Model: CH-C2/CH-C2 Pro	Date: 14-Oct-16	No.: RD257015a
-------------------------------	-----------------	----------------

Subject: Firmware Release Note: PS3		Prepared by: K. Hamada	
From: 1st Tech Service Sect., MFP/Printer Tech Service Dept.			
Classification:	<input type="checkbox"/> Troubleshooting	<input type="checkbox"/> Part information	<input type="checkbox"/> Action required
	<input type="checkbox"/> Mechanical	<input type="checkbox"/> Electrical	<input type="checkbox"/> Service manual revision
	<input type="checkbox"/> Paper path	<input type="checkbox"/> Transmit/receive	<input type="checkbox"/> Retrofit information
	<input type="checkbox"/> Product Safety	<input checked="" type="checkbox"/> Other (Firmware)	<input checked="" type="checkbox"/> Tier 2

This RTB has been issued to announce the firmware release information for the **PS3**.

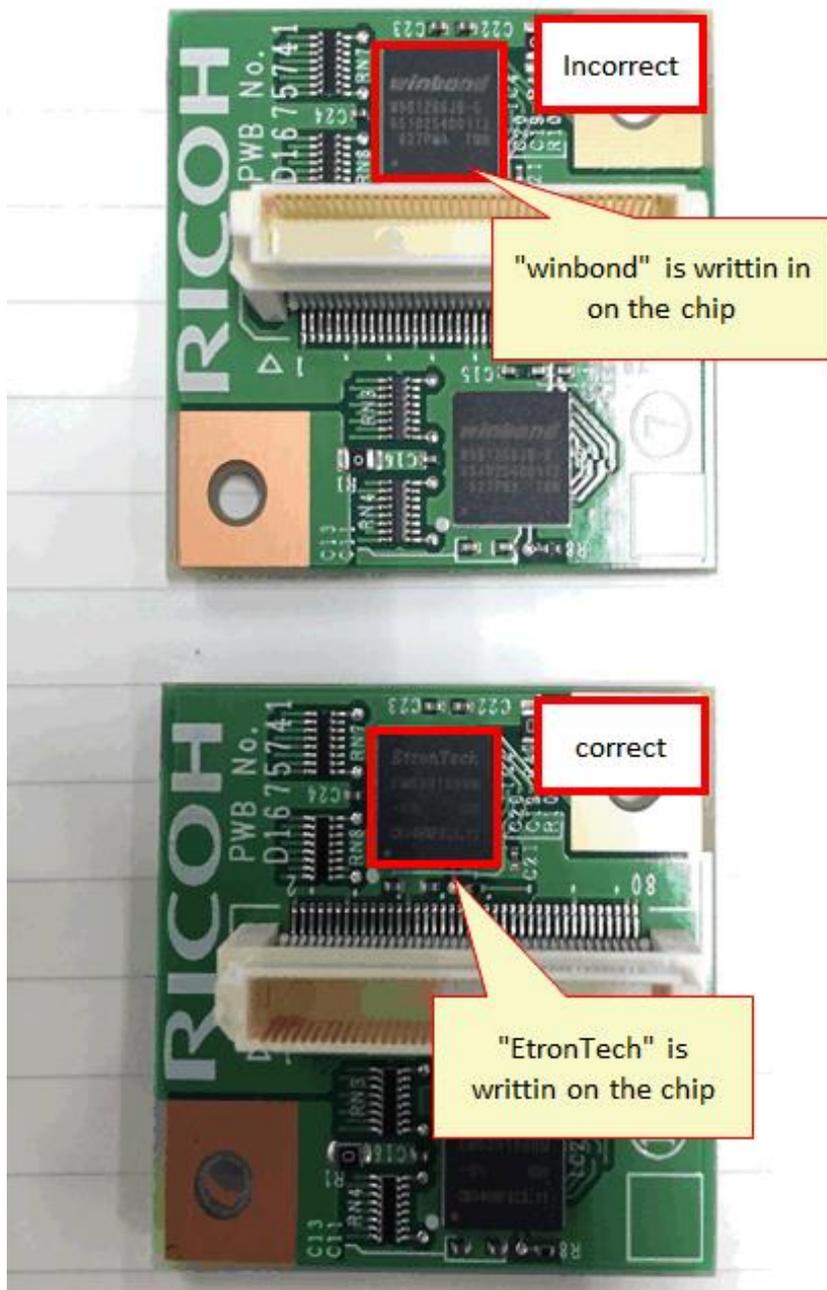
- Changed the value of the resistance on the Fax Memory Unit
- Changed to a different manufacturer of memory modules for the Fax Memory Unit
- The modification has been applied at the factory at Sep 2016.

Replace the Fax Memory Unit with the modified one.

P/N	Description	Q'ty
D2429901	PCB:MEMORY BOARD:ASS'Y	1

Fig 1

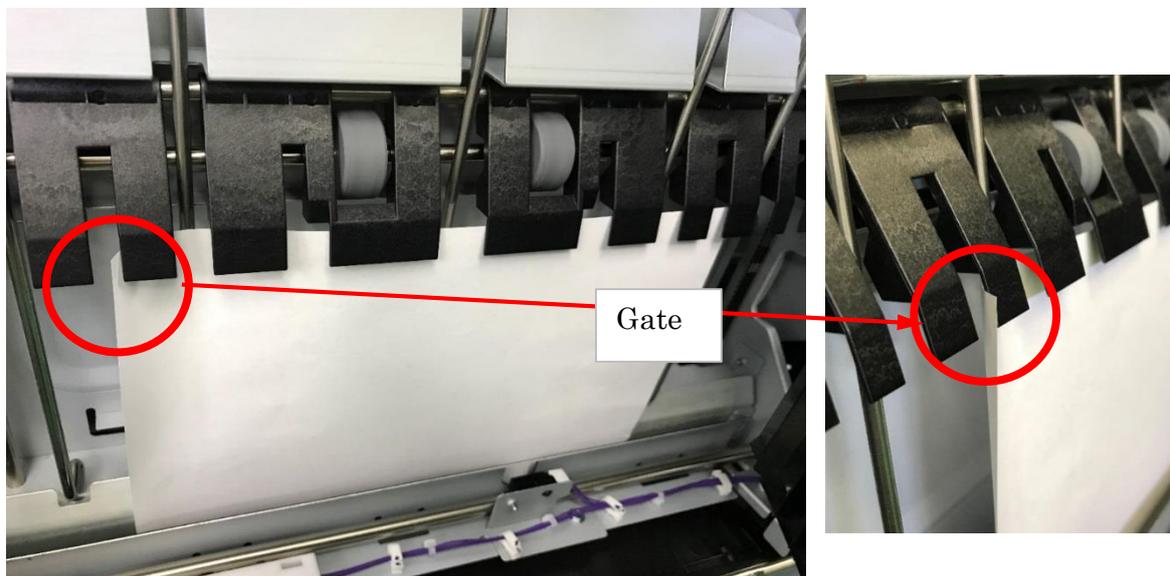
When creating saddle-stitched booklets, the gate holds the stack to prevent the succeeding sheet from colliding with the stack. If the stack has a face-curl, the curled corner can protrude from the slit depending on the paper size as shown in the red circles in Fig1 below. To prevent such instances, paper sizes that have the possibility of the corners to position to these slits are NOT supported.

Fig 2

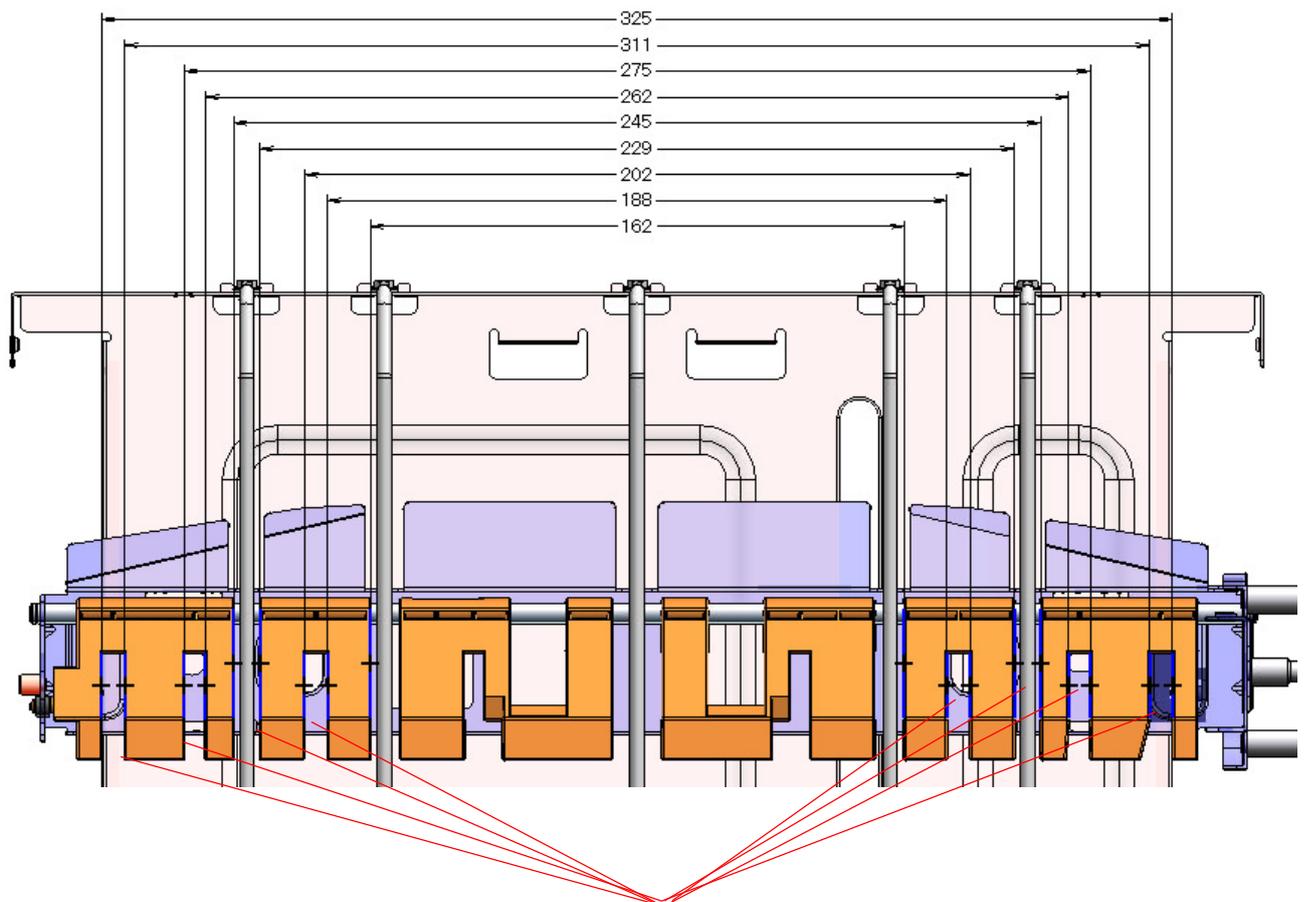
Paper sizes that cause the paper edge to position to these 8 slits on the gate are not supported for saddle-stitching. (Slit area + margin)
 Saddle-stitch is supported for the following custom paper sizes.
Width: 182mm, 207-225mm , 250-257mm, 279.4-306mm, 330-330.2mm
Length: 257-467.2mm

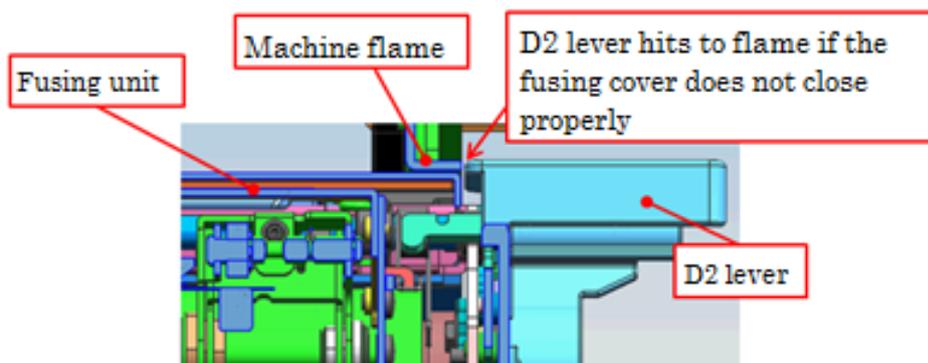
The D2 fusing unit lever hits the machine frame and breaks if the cover of the fusing unit does not close properly.

Replace the fusing unit D2 lever with the new part.

Old part number	New part number	Description	Q'ty	Int	Note
D2584359	D2584372	GRIP:SEPARATION:OPEN AND CLOSE:ASS'Y	1	X/O	-

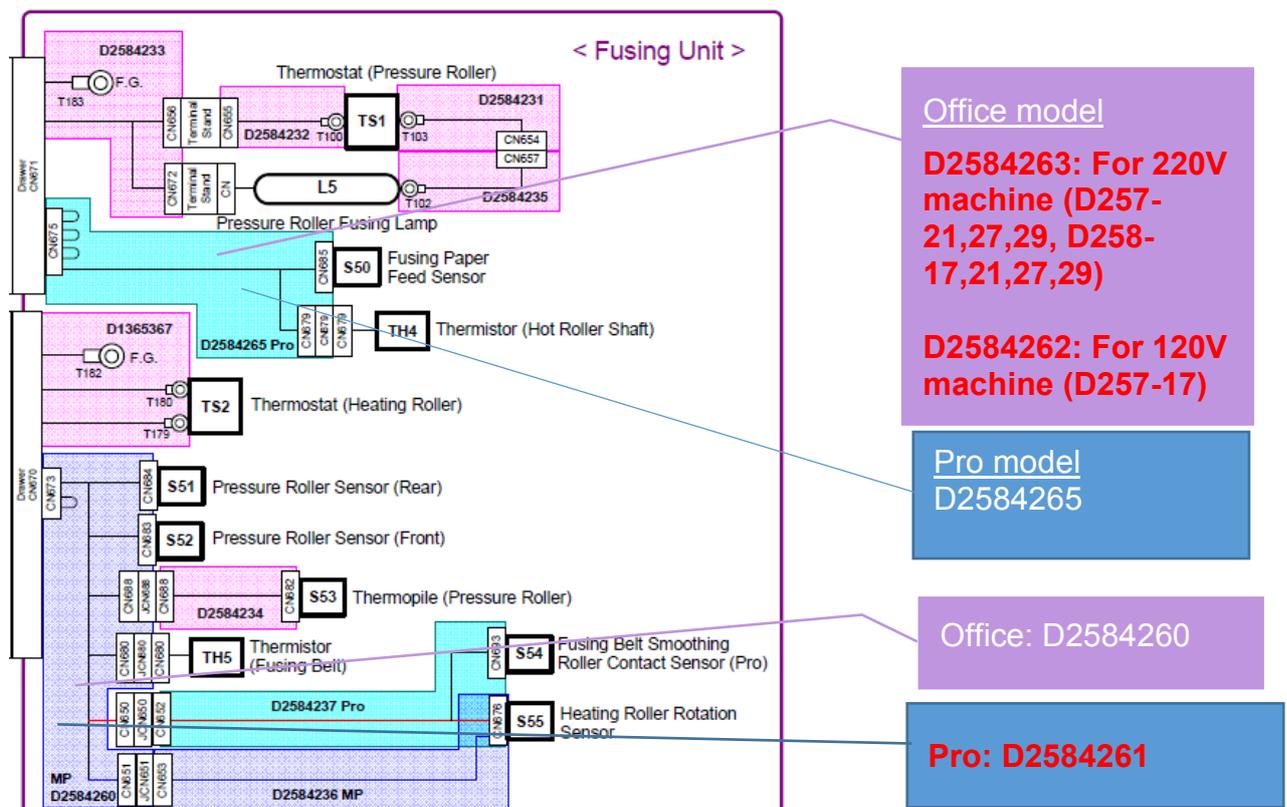
Change: The above three part numbers were added to the P-to-P diagram.

Reason: The part numbers were missing from the P-to-P diagram.

Incorrect

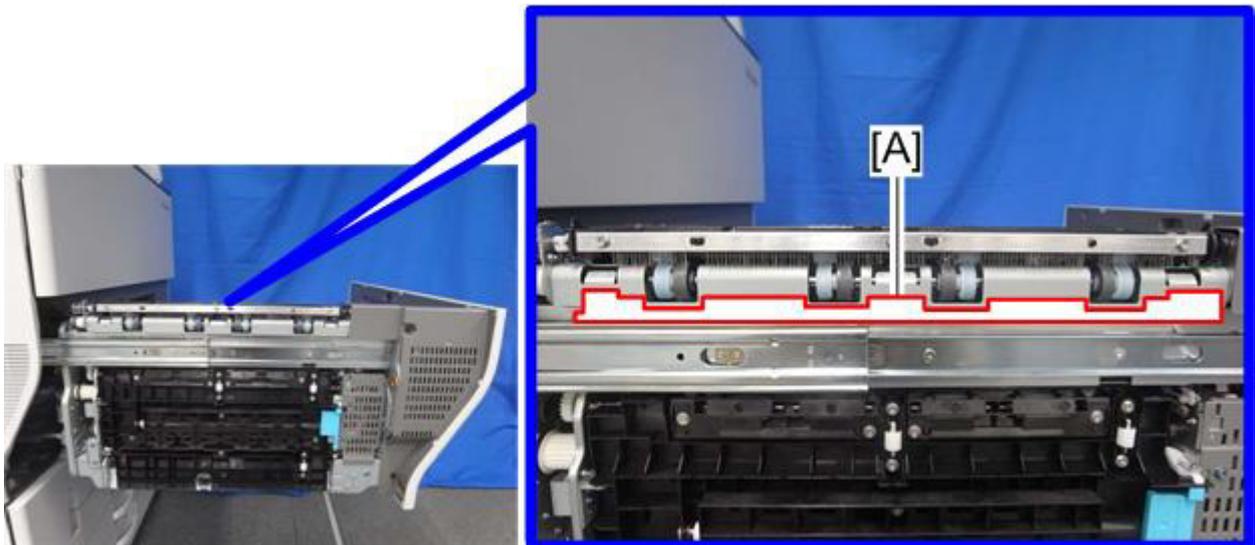
Please correct the Copy Tray Type M26 Installation procedure described in the section:
2. Installation > Copy Tray Type M26(D3D2)

12. Attach the sheet [A] to the left side of the drawer unit.

There are four cutouts in the sheet.

Correct

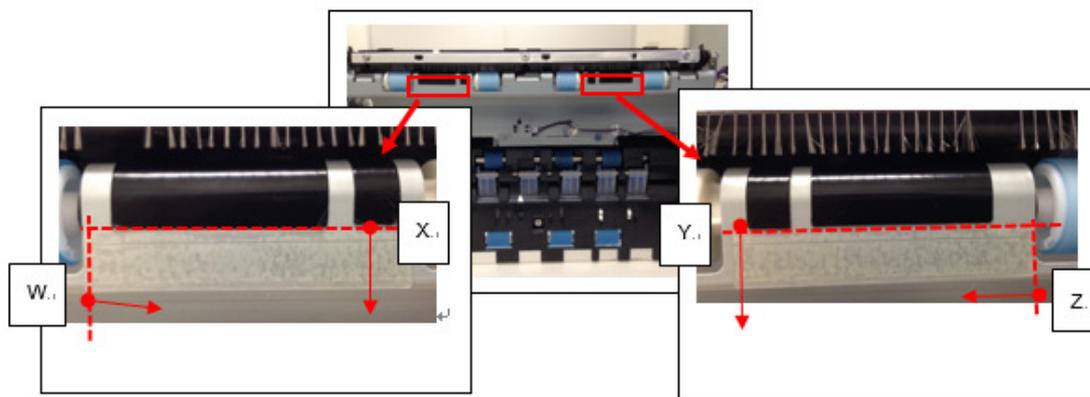
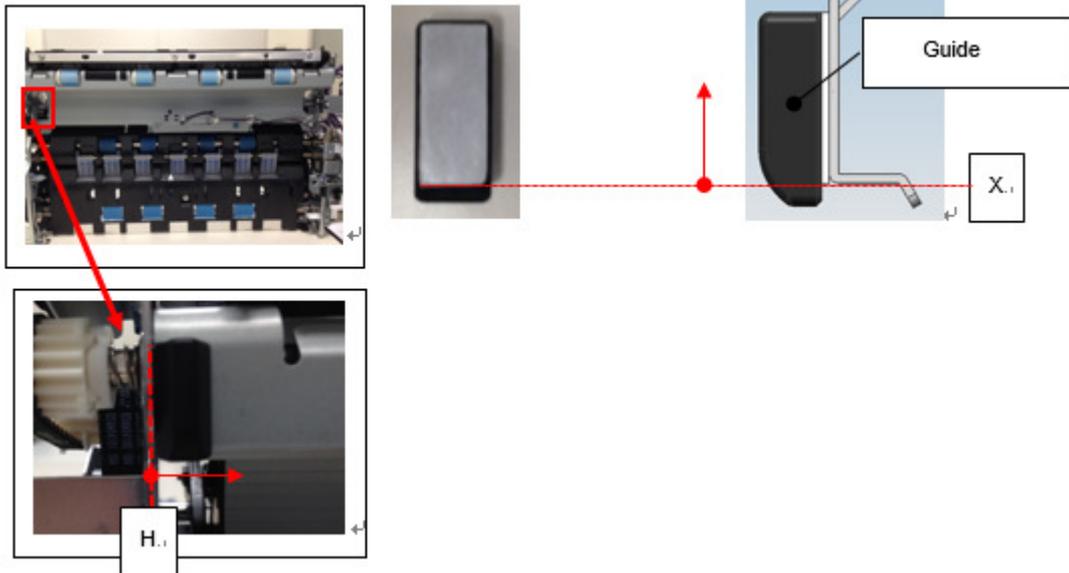
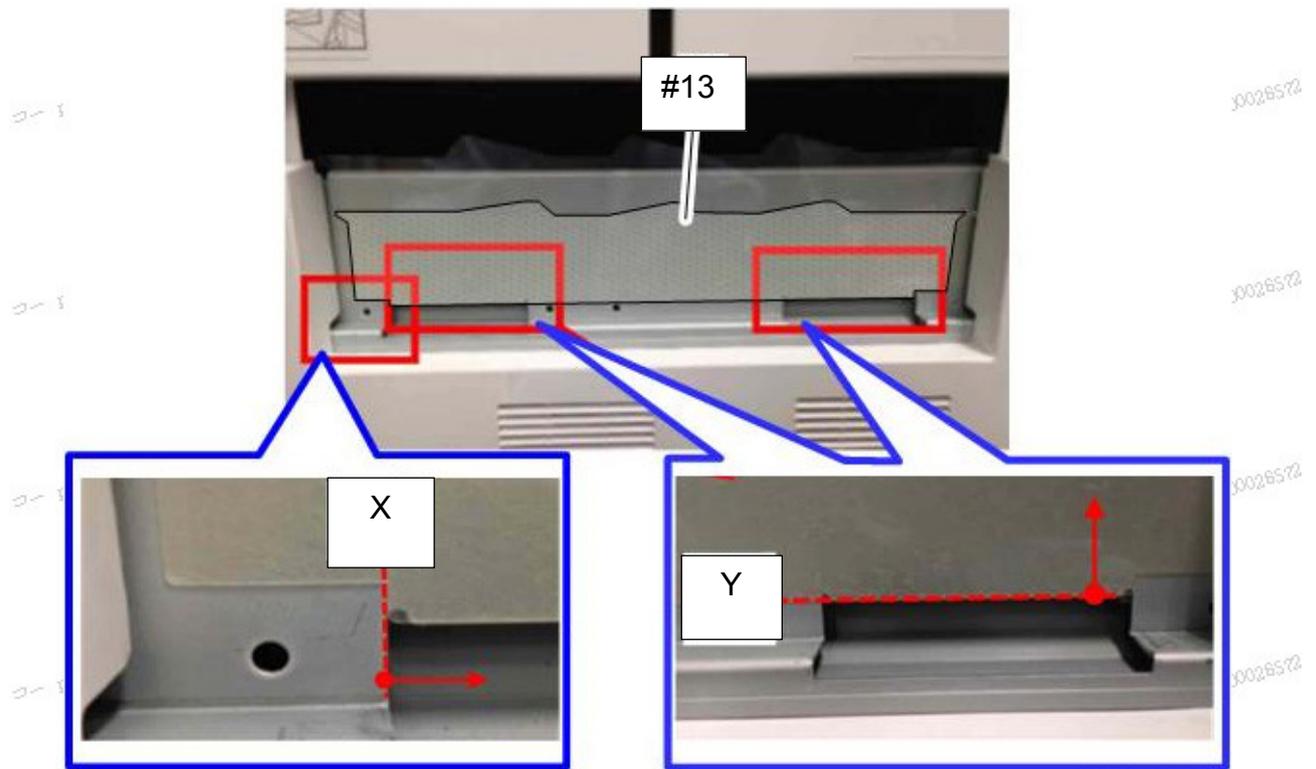
- Attach the guide [#23] and sheet [#13] in the following two steps.

- a. With the drawer unit pulled out, attach the guide [#23] to the non-operator side of the paper exit unit by aligning the edge H with edge X.

- b. Attach the sheet [#13] to the exit of the mainframe by aligning the corner X with edge Y.

POINT TO POINT DIAGRAM (3/6) G11-J16

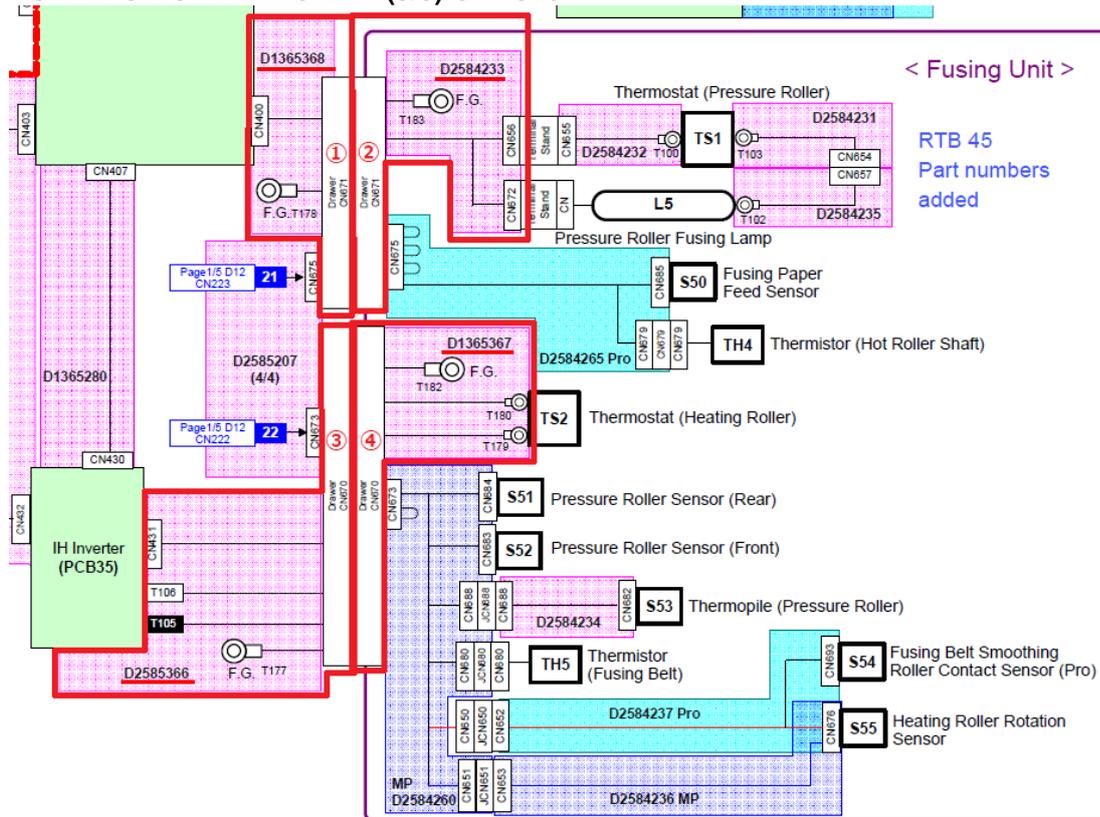
Model: CH-C2a		Date: 8-May-18	No.: RD257047
Subject: Drawer connector P/N correction		Prepared by: H.Kameda	
From: Technical Support Sect., Product Marketing Dept.			
Classification:	<input type="checkbox"/> Troubleshooting	<input checked="" type="checkbox"/> Part information	<input type="checkbox"/> Action required
	<input type="checkbox"/> Mechanical	<input type="checkbox"/> Electrical	<input checked="" type="checkbox"/> Service manual revision
	<input type="checkbox"/> Paper path	<input type="checkbox"/> Transmit/receive	<input type="checkbox"/> Retrofit information
	<input type="checkbox"/> Product Safety	<input type="checkbox"/> Other ()	<input type="checkbox"/> Tier 2 <input type="checkbox"/> Tier 0.5

U010_S001: TRANSFER UNIT: INTERMEDIATE TRANSFER

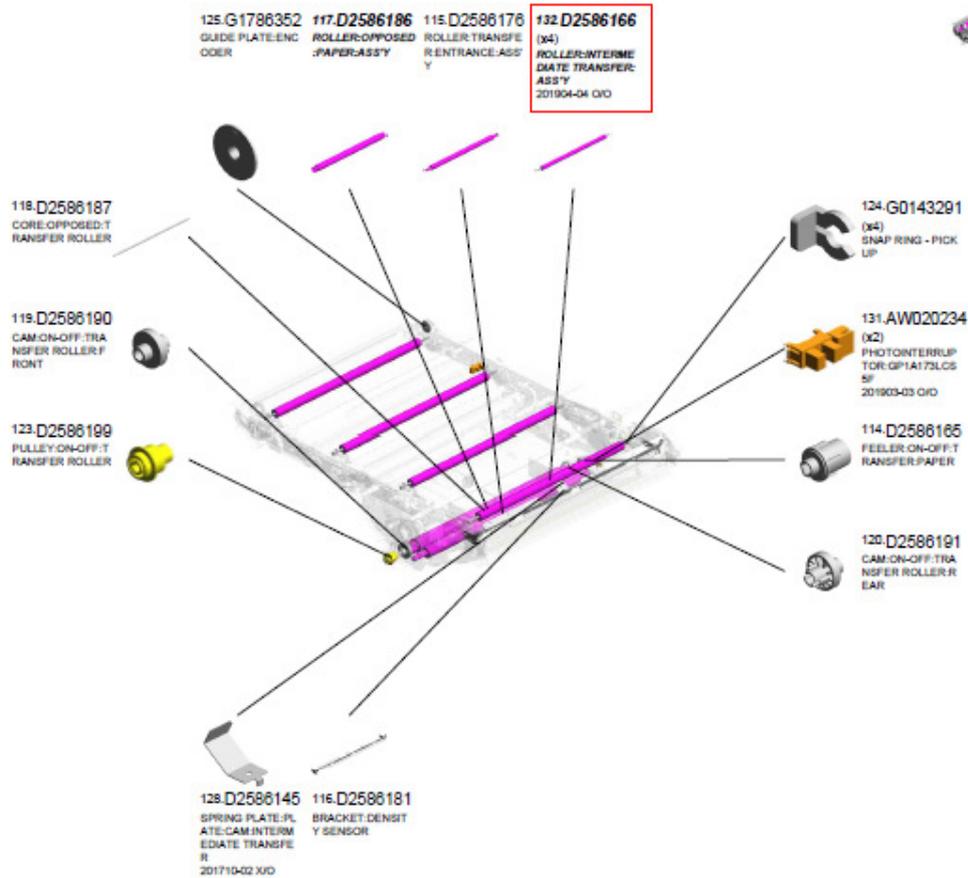
For any replacement of the image transfer roller that takes place after July 21, 2019 for MP C6503/ C8003, please make sure to replace it with the new roller (p/n: D2586166).

3D parts catalog was revised as follows.

201904-04	1904 Modification		D0746158	ROLLER:INTERMEDIATE TRANSFER:ASS'Y	D2586166	ROLLER:INTERMEDIATE TRANSFER:ASS'Y	U010_S001	132	1	
			D0746158	ROLLER:INTERMEDIATE TRANSFER:ASS'Y	D2586166	ROLLER:INTERMEDIATE TRANSFER:ASS'Y	U010_S001	132	1	
			D0746158	ROLLER:INTERMEDIATE TRANSFER:ASS'Y	D2586166	ROLLER:INTERMEDIATE TRANSFER:ASS'Y	U010_S001	132	1	
			D0746158	ROLLER:INTERMEDIATE TRANSFER:ASS'Y	D2586166	ROLLER:INTERMEDIATE TRANSFER:ASS'Y	U010_S001	132	1	
			D0746158	ROLLER:INTERMEDIATE TRANSFER:ASS'Y	D2586166	ROLLER:INTERMEDIATE TRANSFER:ASS'Y	U010_S002	132	1	
			D0746158	ROLLER:INTERMEDIATE TRANSFER:ASS'Y	D2586166	ROLLER:INTERMEDIATE TRANSFER:ASS'Y	U010_S002	132	1	
			D0746158	ROLLER:INTERMEDIATE TRANSFER:ASS'Y	D2586166	ROLLER:INTERMEDIATE TRANSFER:ASS'Y	U010_S002	132	1	
			D0746158	ROLLER:INTERMEDIATE TRANSFER:ASS'Y	D2586166	ROLLER:INTERMEDIATE TRANSFER:ASS'Y	U010_S002	132	1
